21-COA-0058
736 Zane St.

Limerick Architectural Review Committee
Public Hearing

Bradley Fister, Historic Preservation Specialist
June 30, 2021

Certificate of Appropriateness:

FRONT ELEVATION

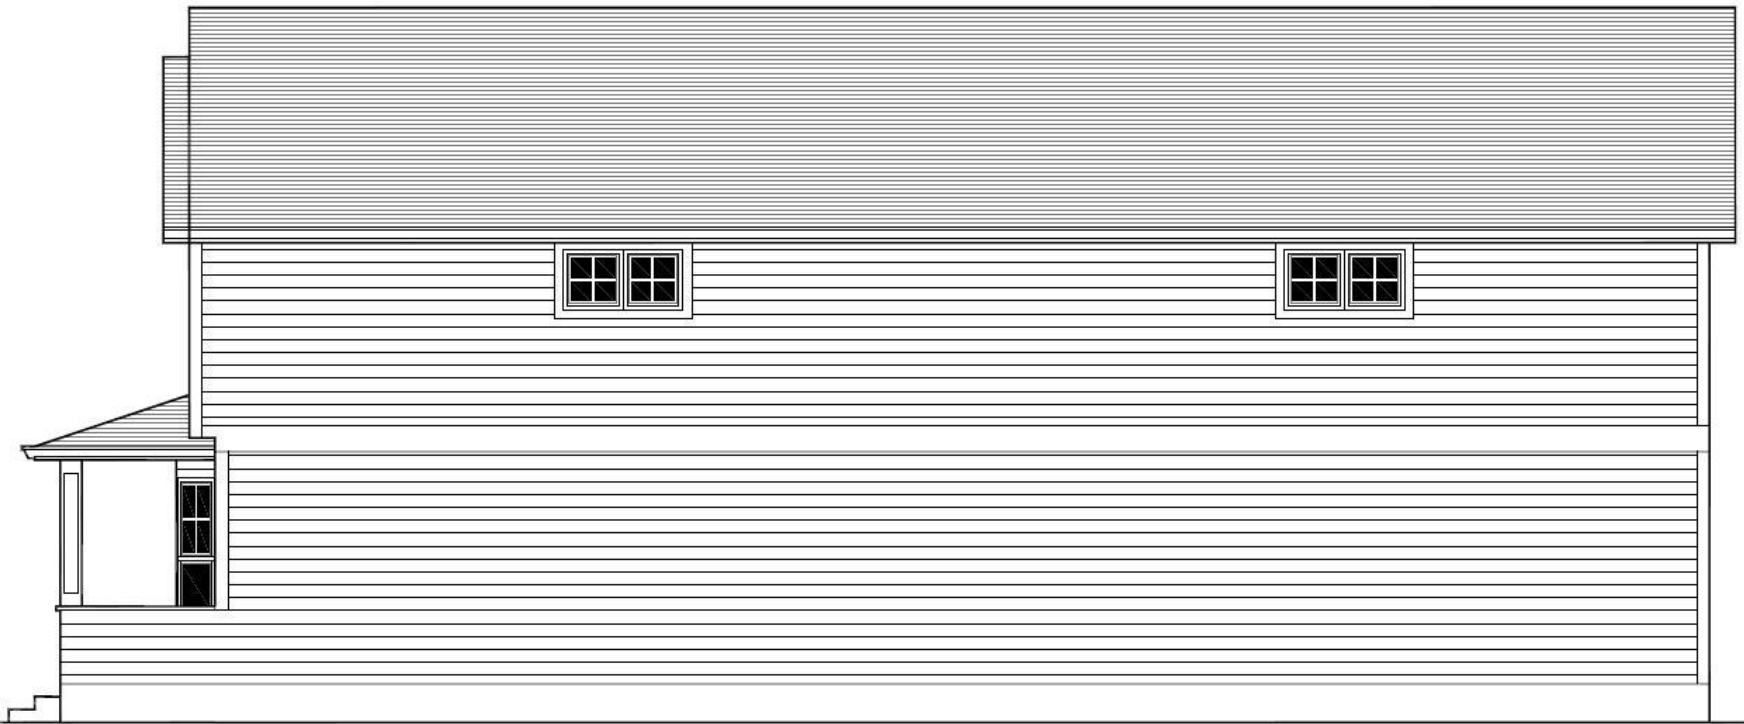
1. Applicant shall conform to all LDC regulations in terms of new construction including minimum tree requirement.
2. Any exposed wood shall be painted or stained within 6 months of construction.
3. The lap siding on the building shall be either 3” or 4” reveal running horizontally.

4. There shall be no flush eaves. Eaves shall project a minimum of 4” from the facades.
5. Final material selections shall be reviewed and approved by staff.
6. Exterior lighting shall not exceed 2.0 footcandles and shall be directed away from historic properties.
7. All concrete work visible from public view shall be of historic concrete mix.
